Access Compliance Report

Public Rights-of-Way

(Curb Ramps)

Intersection ID: 27815	Main Street: BRAID_HILLS_DR	Cross Street: PROVIDENCE_COUNTRY_CLUB_DR	Location: E
ADA ID: A4019E6F4963	Ramp Type: Perp	Initial Pass/Fail: Fail	Overall Compliance: No
Severity Score: 12.5			
Codes/Mitigation Info/Possible Solution		Field Measurements/Component Compliance

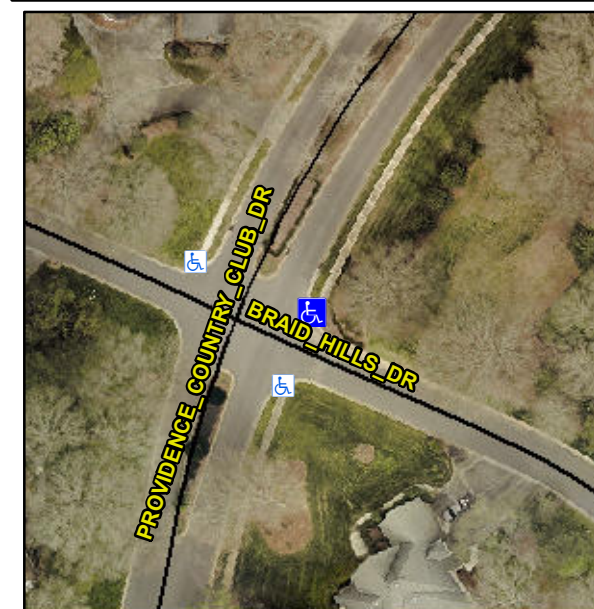
Not Found, R304.5.3

Compliance	Description	Data	Compliance	Description	Data
N/A	Ramp Length (in)	34.5	Yes	Ramp Slope (%)	5.1
Yes	Ramp Width (in)	48.0	No	Ramp XSlope (%)	5.6
N/A	Flare Type LT	N/A	N/A	Flare Type RT	N/A
N/A	Flare Slope LT (%)	N/A	N/A	Flare Slope RT (%)	N/A
N/A	Flare Traversable LT?	N/A	N/A	Flare Traversable RT?	N/A
N/A	Landing Length (in)	N/A	N/A	DWS Provided?	N/A
N/A	Landing Width (in)	N/A	N/A	DWS Contrast?	N/A
N/A	Landing Slope (%)	N/A	N/A	DWS Length (in)	N/A
N/A	Landing X Slope (%)	N/A	N/A	DWS Full Width?	N/A
N/A	Landing Curb? (Y/N)	N/A	N/A	DWS Offset (in)	N/A
N/A	Shared Landing?	N/A			
N/A	Gutter Ponding?	N/A	N/A	Gutter Slope (%)	N/A
N/A	Gutter Lip Ht (in)	N/A	N/A	Gutter X Slope (%)	N/A
N/A	Painted X Walk1?	No	N/A	Painted X Walk2?	N/A
	X Walk 1 Direction	To SW		X Walk 2 Direction	N/A
N/A	X Walk 1 Width (in)	N/A	N/A	X Walk 2 Width (in)	N/A
	X Walk 1 Slope (%)	2.2		X Walk 2 Slope (%)	N/A
	X Walk 1 X Slope (%)	2.5		X Walk 2 X Slope (%)	N/A

Remove & Replace Entire Ramp.
